Backside of flange with ribs and less material

Product Change Notification					PCN 1621			
owner	creation date	release date	released by	change order no	rev	page	D40 055 745	
kesslema	01.03.2021	01.03.2021	muehlema	2021558	Α	1 of 1	D10-055-715

3 Detailed description of change

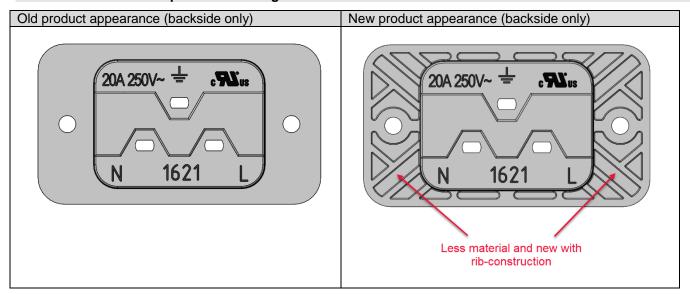
Form Yes Less material and new a rib construction on the backside of flange

To improve the moulding process and to avoid flow lines
